TECHNICAL BULLETIN

REPLACEMENT OF PLENUM WALL FITTINGS – TORQUE PRESSURE GAGE TUBING AND ENGINE OIL PRESSURE GAGE TUBING

All Model 369H Series Helicopters equipped with PN 369A8010-665 or PN 369A8010-677 Tube Assemblies for Engine Oil Pressure Gage and Torque Pressure Gage*

Figure 1. Replacement Of Plenum Wall Fittings - Oil/Pressure Gage Tubing Torque.

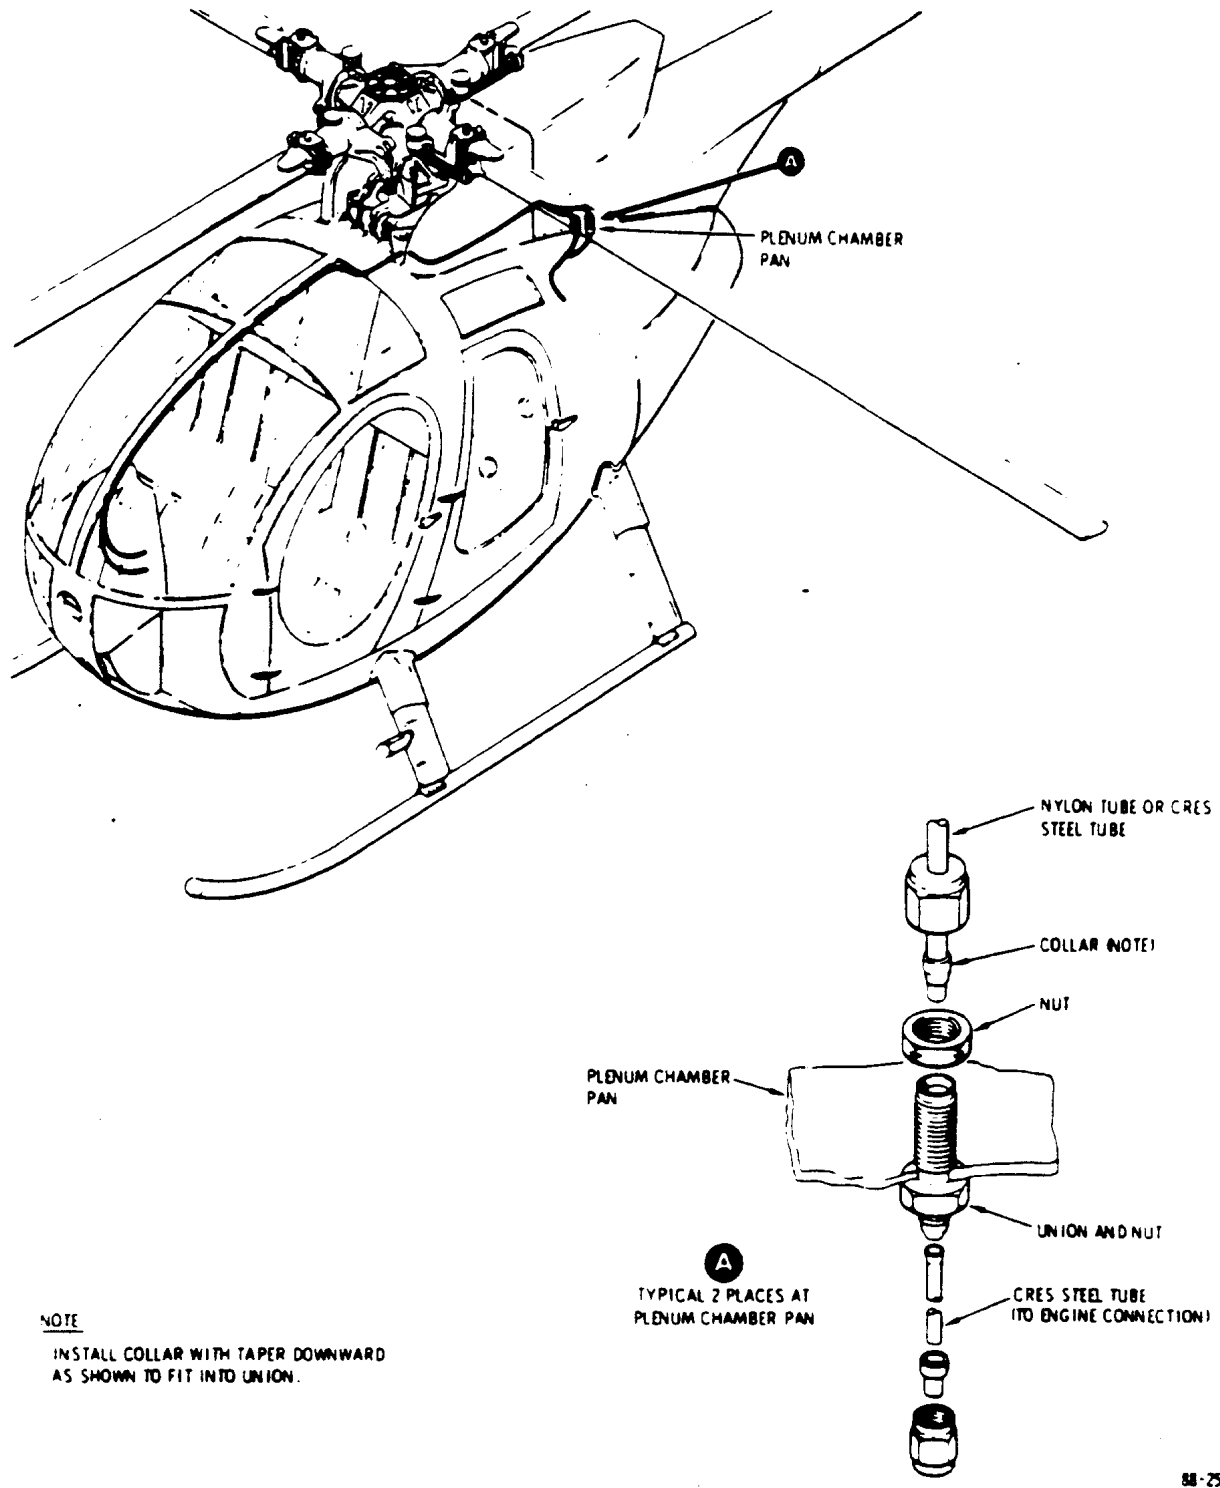
Field reports indicate that breakage and damage to the reducer installed on the plenum chamber pan fitting has occurred during normal service or removal and installation of the engine oil pressure line. Installation of new type fittings is recommended for both the torque pressure gage line and engine oil pressure gage line, to facilitate removal and installation of the tube assemblies and preclude possible breakage and failure of the fittings.

- (3). Open LH engine compartment access door.
- (4). Disconnect pressure line nuts at forward and aft sides of both plenum chamber pan fittings. Cap pressure lines. Refer to Basic HMI.
- (5). Remove existing fittings (reducers and unions) from plenum chamber pan.
- (6). Install new AS12-3XH2BZ-SS-T fittings at plenum chamber pan, as shown in Figure 1.
- (7). Uncap lines and connect forward and aft sections of engine oil pressure and torque pressure gage lines to new fittings.
- (8). Check installation of new fittings for discrepancies.
- (9). Perform pressure and leak test of both lines between engine and gages at 200psi.
- (10). Bleed and service oil pressure lines, per basic HMI.
- (11). Close engine compartment access door. Reinstall aft bulkhead access cover and engine air intake fairing.
